T10/07-094 revision 1

Subject: SAS-2:UML changes for logical phys

4.1.3 Physical links and phys

Figure 1 — Phy class diagram

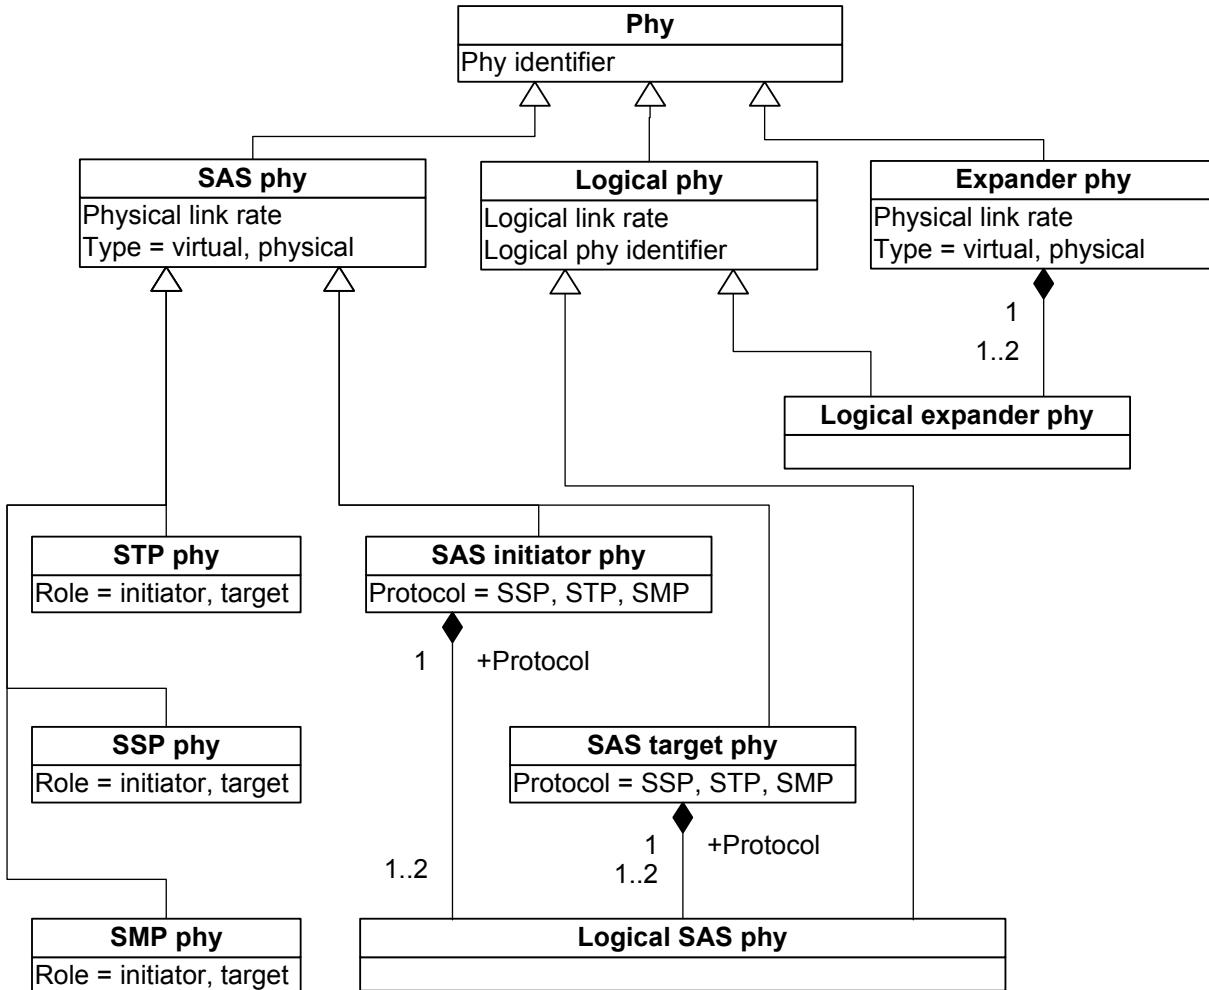
When logical phys were added as a result of the multiplexing proposal the phy UML diagrams for the new logical phy class and logical expander phy class were not updated. This proposal recommends changes to the phy UML diagram that for those new classes.

Figure 1 defines the phy classes, showing the relationships between the following classes:

- a) phy;
- b) SAS phy;
- c) logical phy;
- d) expander phy;
- e) logical SAS phy;
- f) logical expander phy;
- g) SAS initiator phy;
- h) SAS target phy;
- i) SSP phy;
- j) STP phy; and
- k) SMP phy.

Figure 2 — SAS phy object and logical SAS phy object diagram

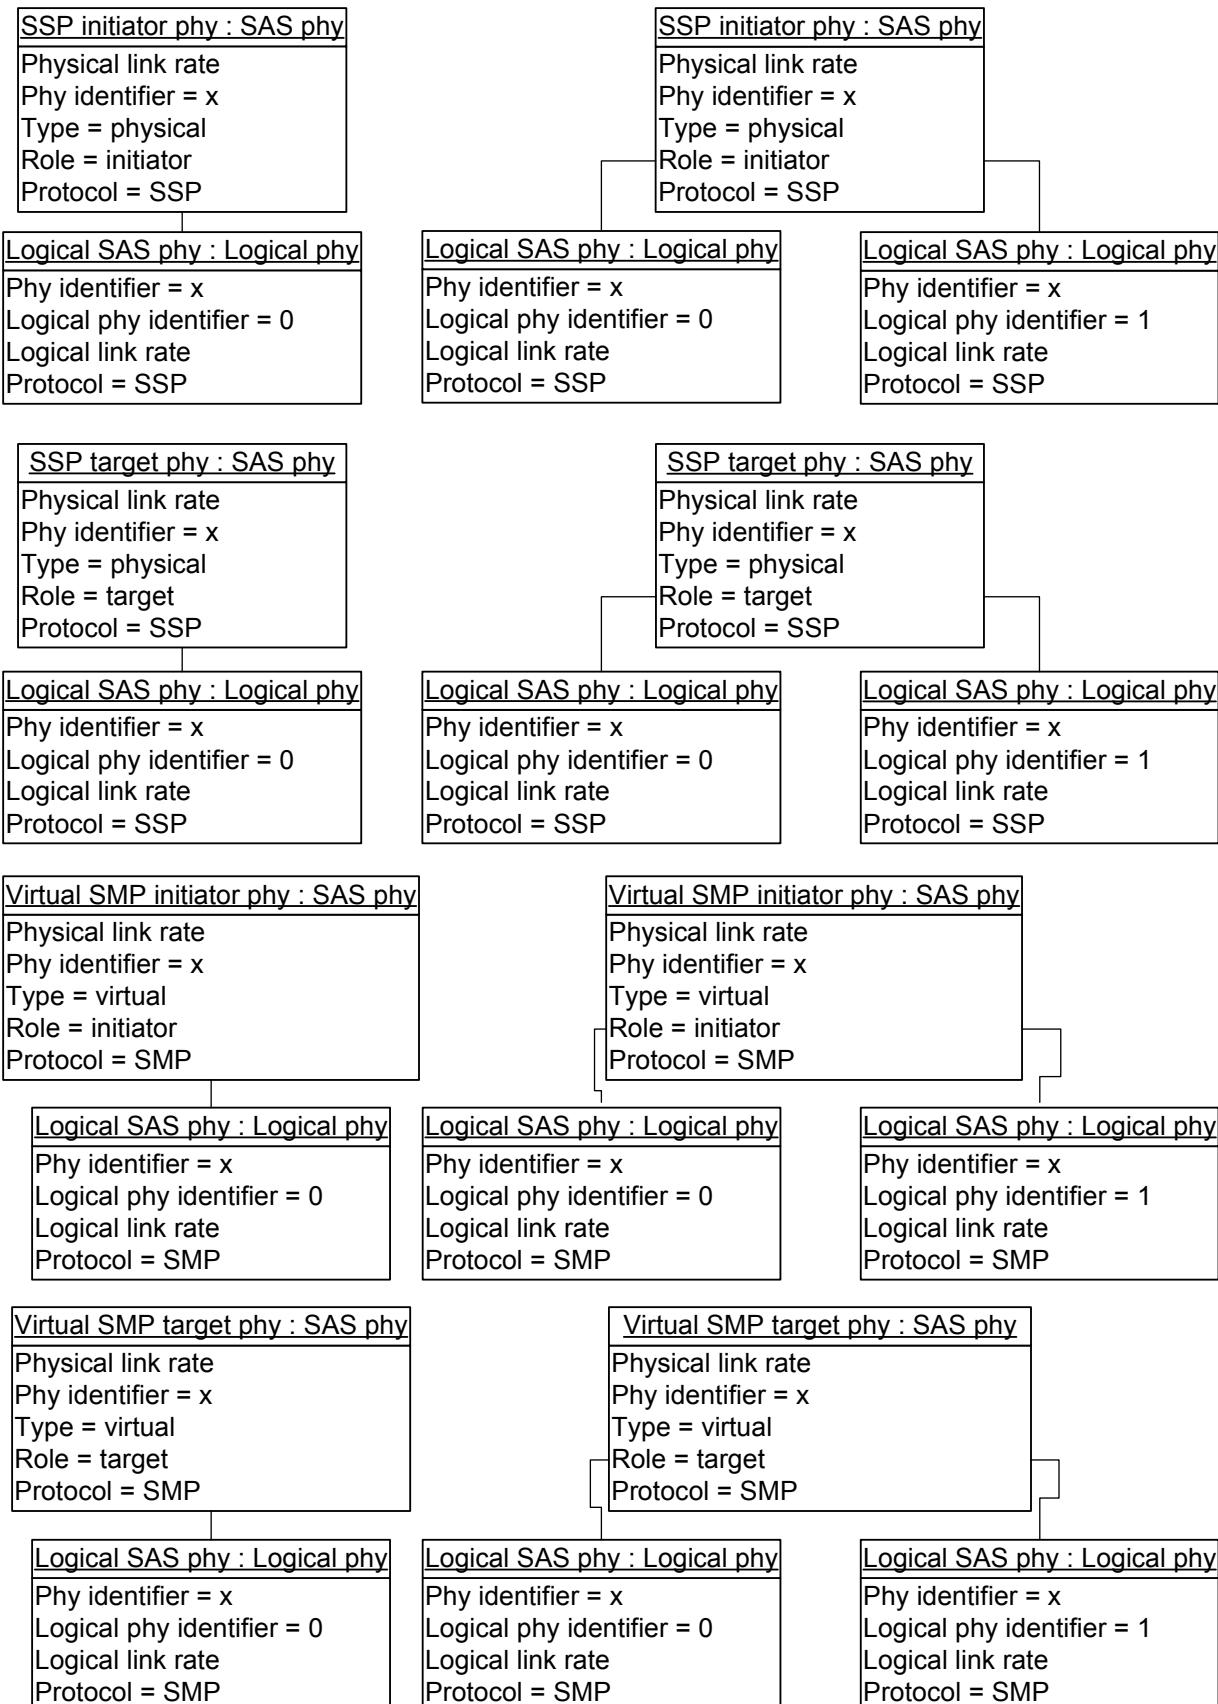
Figure 2 shows the examples objects instantiated from the SAS phy class and the logical phy class, including:

- SSP initiator phy;
- SSP target phy;
- virtual SMP initiator phy;
- virtual SMP target phy; and
- logical SAS phy.

A SAS phy and logical SAS phy is represented by one of these objects during each connection. A SAS phy and a logical SAS phy may be represented by different SAS phy objects and logical SAS phy objects in different connections.

Figure 3 — Expander phy object diagram

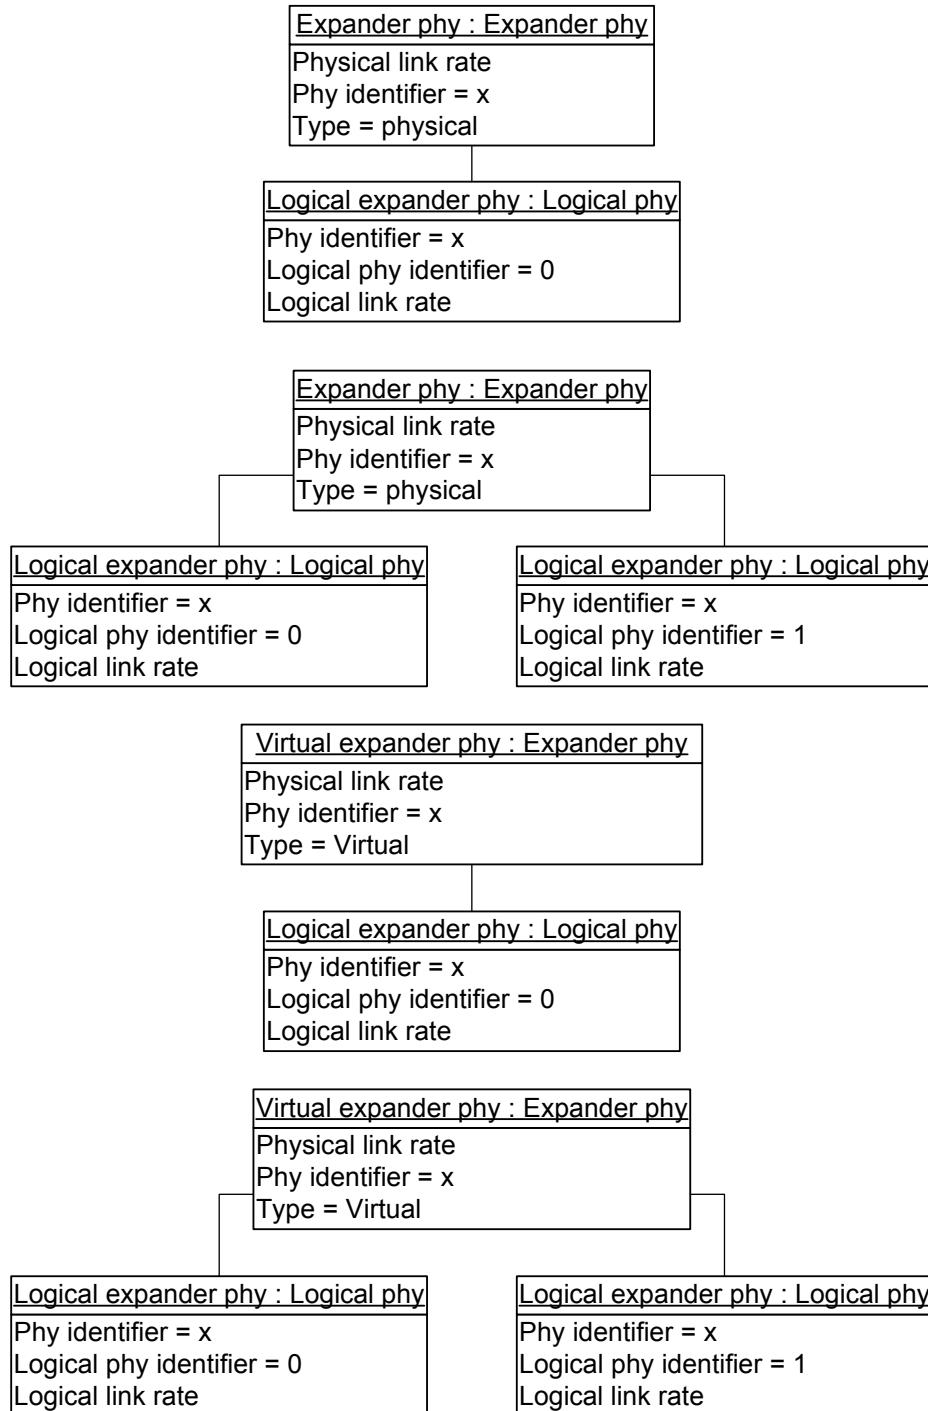
Figure 3 shows the objects instantiated from the expander phy class and the logical phy class, including:

- a) expander phy;
- b) virtual expander phy; and
- c) logical expander phy.

An expander phy and logical expander phy is represented by one of these objects during each connection. An expander phy and a logical expander phy may be represented by different expander phy objects and logical expander objects in different connections.
